# DESCRIPTIVE REPORT TO ACCOMPANY HYDROGRAPHIC SURVEY H-10193 HFP-10-4-85

#### APPROVAL SHEET SURVEY H-10193 (HFP-10-4-85)

#### ATLANTIC MARINE CENTER EVALUATION REPORT

Examination of Hydrographic Survey H-10193 (1985-1986), Maryland,

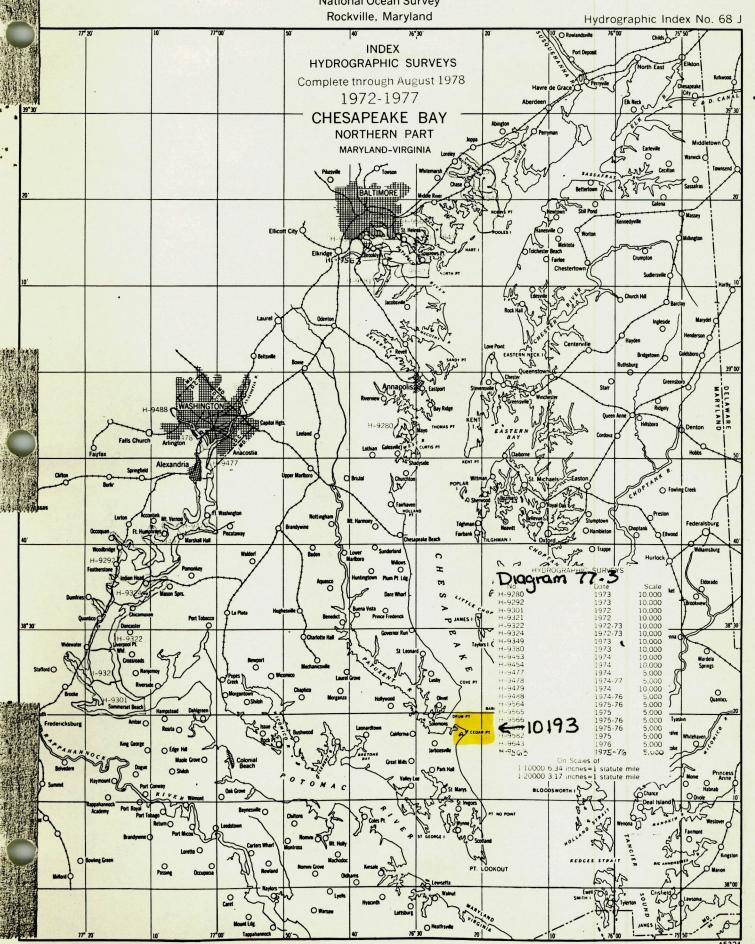
AWOIS item #4007, a charted dangerous sunken wreck with a known depth of 27 feet in Latitude 38°18'45.47"N, Longitude 76°25'01.57"W, originates with prior survey H-6876 (1944). A 27 foot depth recorder sounding was obtained on the wreck by prior survey H-6876 (1944). A leadline least depth from the prior survey recorded a 32 foot depth. The wreck was located by the present survey in Latitude 38°18'44.91"N, Longitude 76°25'00.60"W with and echo sounder least depth of 34 feet. While this may be the shoalest depth determined for this item it should not be considered the least depth. The present survey position is 29.2 meters southeast of the position on prior survey H-6876 (1944). No change in charting status is recommended. It is recommended that additional work be performed at an opportune time to determine a least depth on the wreck and the extent of the wreck and/or wreckage.

This is an adequate basic survey. Additional work is recommended to verify or disprove AWOIS items 3678, 3680, and 4007.
